Noise During Start Up – Install Revised Timing Chain Tensioners

MODEL1997-99 MY XK8 Range
1998-99 MY V8 XJ Series**VIN**Refer to engine
no. in text**Issue:**

ILLUSTRATION 1

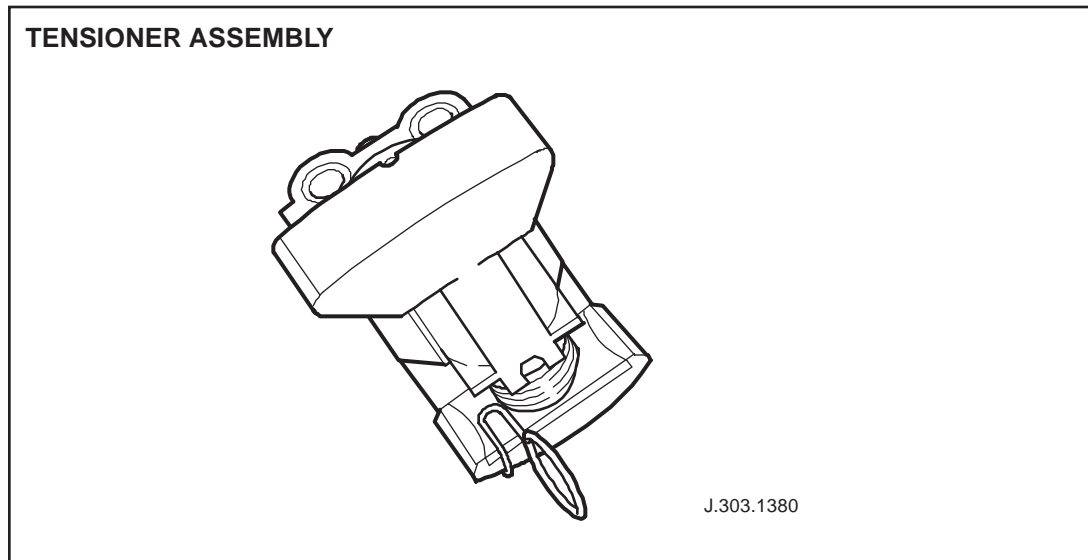
In case of a customer complaint of start up noise, determine if the noise is caused by the secondary timing chain tensioners. If the secondary timing chain tensioners are the cause of the noise, they should be replaced by the revised tensioners (Illustration 1).

- The revised tensioner has a coil spring that presses on the piston head to provide a damping effect.
- To simplify the installation of the tensioner on the engine, a clip (shown in Illustration 2) is provided to hold the piston in a partly compressed position during assembly.

ILLUSTRATION 2

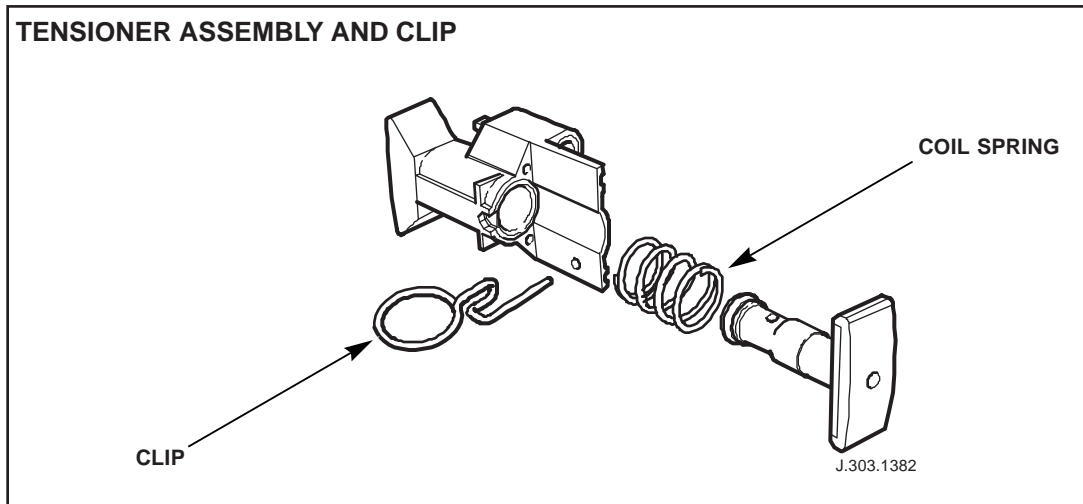
- When the piston and spring assembly is compressed to approximately half of its travel, the pin end of the clip is inserted into the hole in the tensioner body, in front of the piston head/slipper, with the finger ring of the clip positioned at the rear of the head, (as shown in Illustration 1).
- Installation of the tensioners is covered in JTIS 5, section 303-01, Basic Engine, Removal and Installation, Timing Chain Tensioner (Secondary) - A-Bank (12.65.63) or Timing Chain Tensioner (Secondary) - B-Bank (12.65.64).
- The method of removing and reinstalling the secondary timing chain tensioners has been simplified by the use of a ball-end drive bit as described in Technical Bulletin 303-28, dated 8/98.

ILLUSTRATION 3

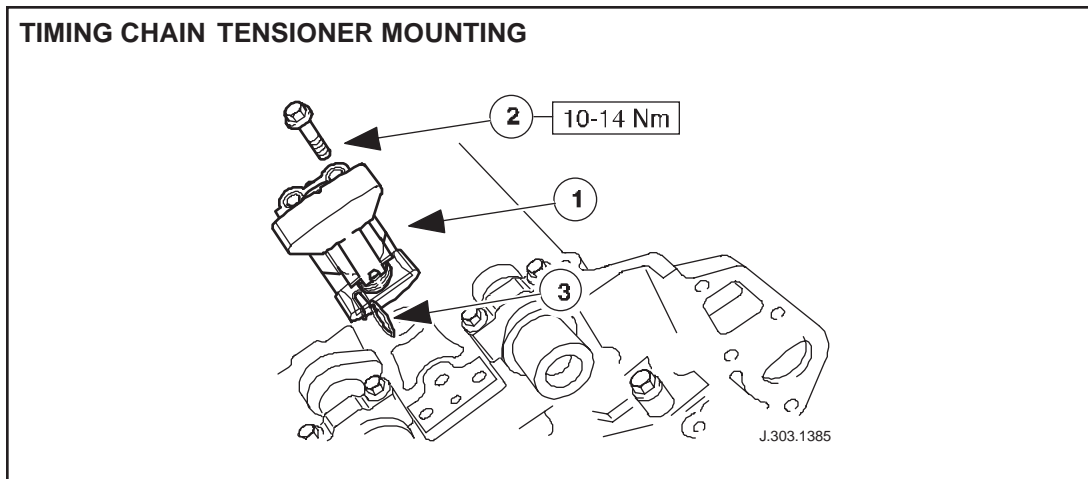
- The installation of the revised tensioner, (1, Illustration 3), is the same as the original style tensioner except that it must be installed in the compressed condition (retained by the clip).
- The retaining bolts should be tightened to the recommended torque setting of 10-14 Nm (7.4-10.3 lb. ft, 88.5-123.9 lb. in.), (2, Illustration 3), before the clip (3, Illustration 3), is removed to release the piston and tension the secondary chain.
